**2<sup>nd</sup> Further Information**

**Proposed Temporary Open Storage of Construction Materials and Machinery and  
Associated Filling of Land for a Period of 3 Years in "Agriculture" Zone,  
Various Lots in D.D. 107, Fung Kat Heung, Yuen Long, New Territories**

**(S.16 Planning Application No. A/YL-KTN/1216)**

**Responses-to-Comments**

DWG NO. PLAN 1	VER. 001
-------------------	-------------

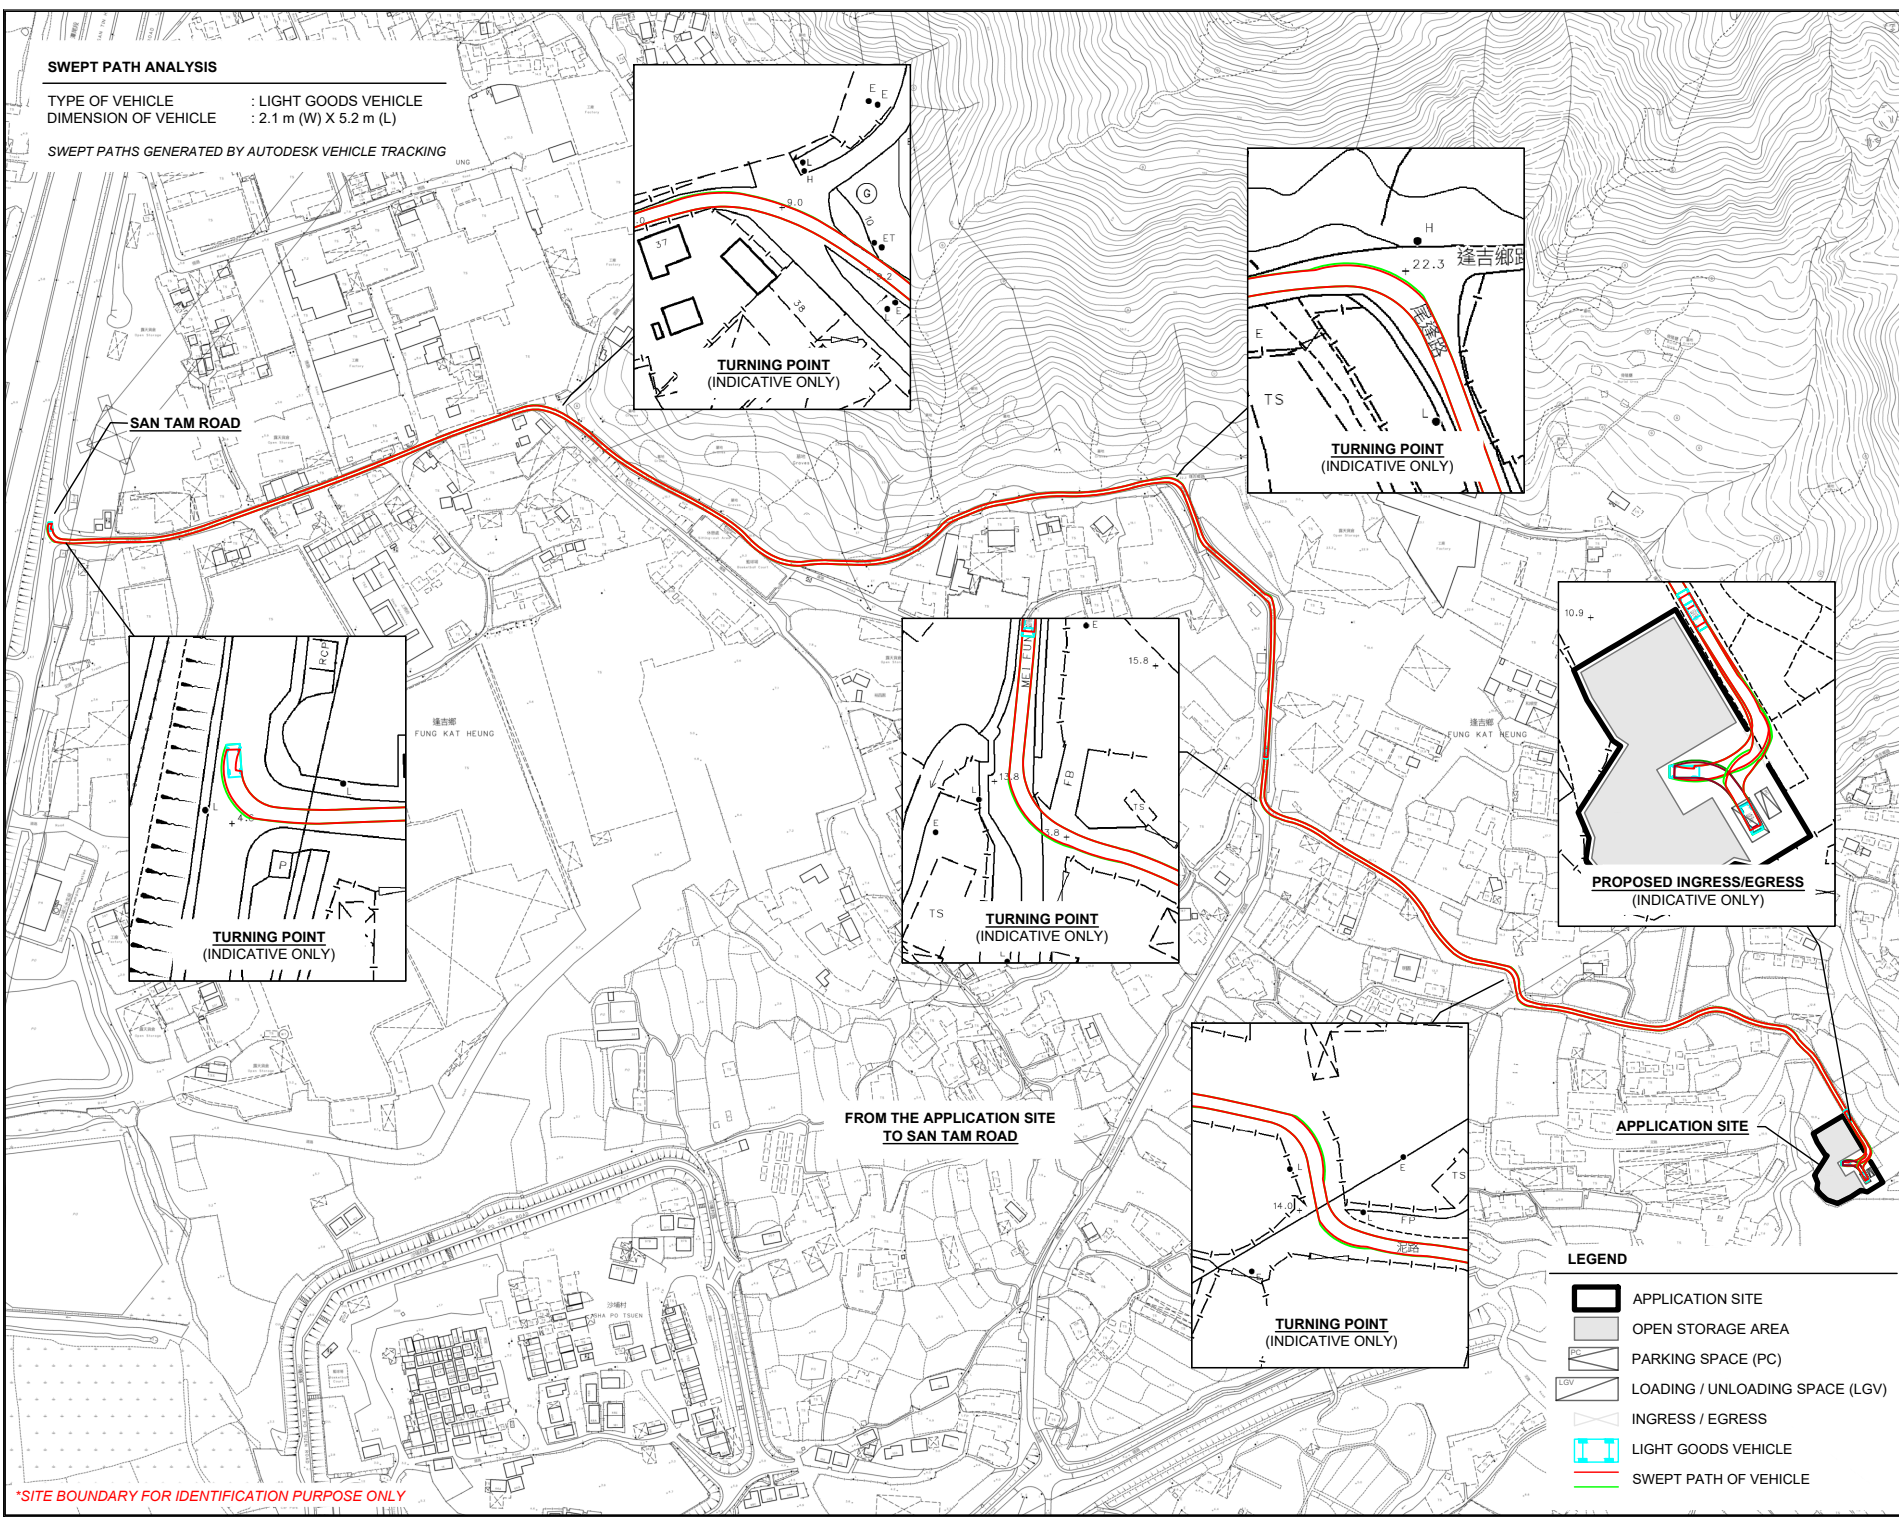
<b>Departmental Comments</b>		<b>Applicant’s Responses</b>
<b>1. Comments of the Commissioner for Transport (C for T)</b> <b>(Contact Person: Mr. Phil CAI; Tel: 2399 2421)</b>		
(a)	For demonstrating the smooth manoeuvring of vehicles, the applicant should indicate with swept path of intended vehicle type passage vide the access, in particular at some turning points and within the Site.	Noted. Swept-path analysis using light goods vehicle with overall dimensions 2.1 m (W) x 5.2 m (L) has been provided to demonstrate the intended vehicle movements through the site access, critical turning points and any loading/unloading manoeuvres ( <b>Plan 1</b> ).
